PROPOSED IMPROVEMENT
BRIDGE PROJECT
TOWN OF WALLINGFORD
COUNTY OF RUTLAND

PROJECT DESCRIPTION: REHABILITATE AND ASSEMBLE HISTORIC TRUSS OVER OTTER CREEK AT THE WALLINGFORD TOWN PARK.

The following Structural Steel shop drawing details for the above project (General Contractor – Renaud Bros , Inc) have been reviewed and are being returned herewith

DRAWING TITLE: Drawings Truss Type 1 General Notes & Drawings
DRAWN BY: JED JOB CONTACT: Erick Foster State of VT
CHECKED BY: JED/AD DATE: 4/30/09

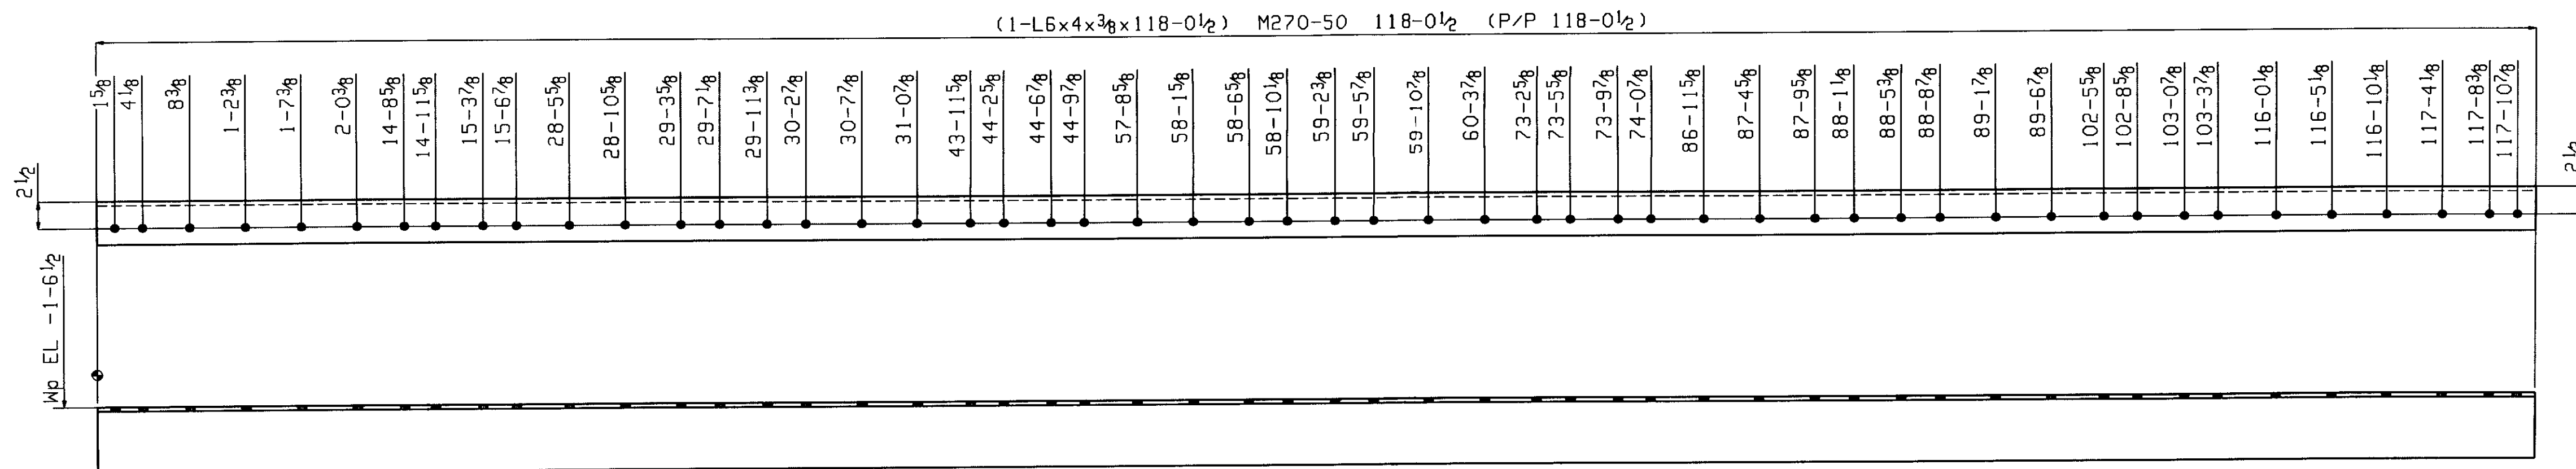
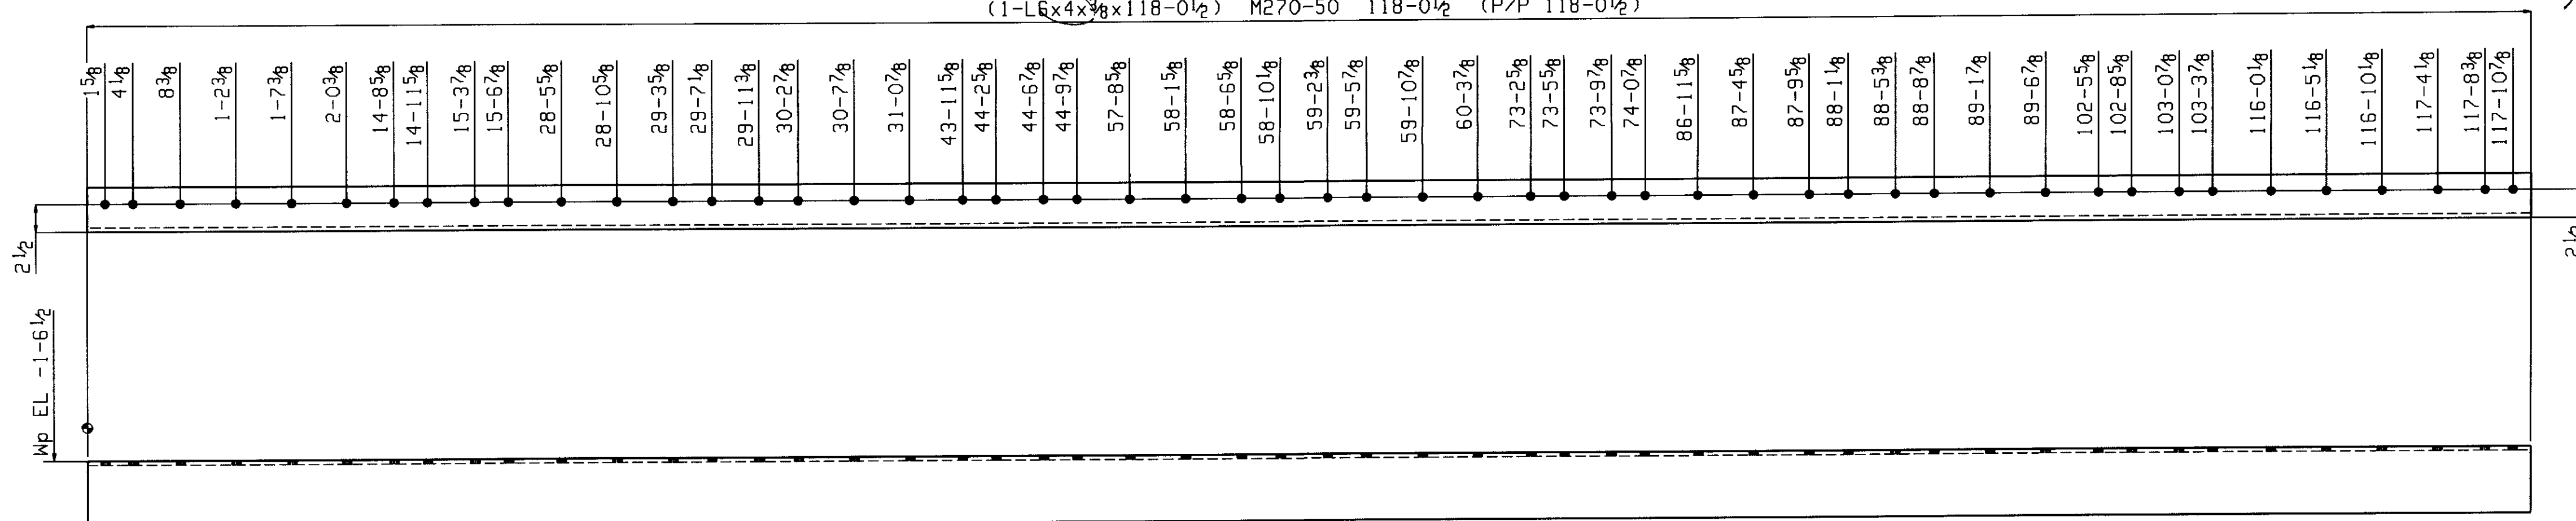
☐ NO EXCEPTION TAKEN
☐ REJECTED
☒ MAKE CORRECTIONS NOTED
☐ REVISE AND RESUBMIT
☐ SUBMIT SPECIFIED ITEM
CLIPPING IS ONLY A FINAL COPY OF THE TIME
OF THE ORIGINAL SUBMITTAL. IT IS NOT TO BE
USED FOR ANY OTHER PURPOSE. THE ORIGINAL
SUBMITTAL IS THE ONLY COPY TO BE USED FOR
CONSTRUCTION. THE ORIGINAL SUBMITTAL IS THE
ONLY COPY TO BE USED FOR CONSTRUCTION.
CLOUGH HARBOUR & ASSOCIATES LLP
ENGINEERS - ARCHITECTS - INTERIORS
6000 ROUTE 100, SUITE 100
PORTLAND, ME 04106
DATE 6/1/09 BY [Signature]
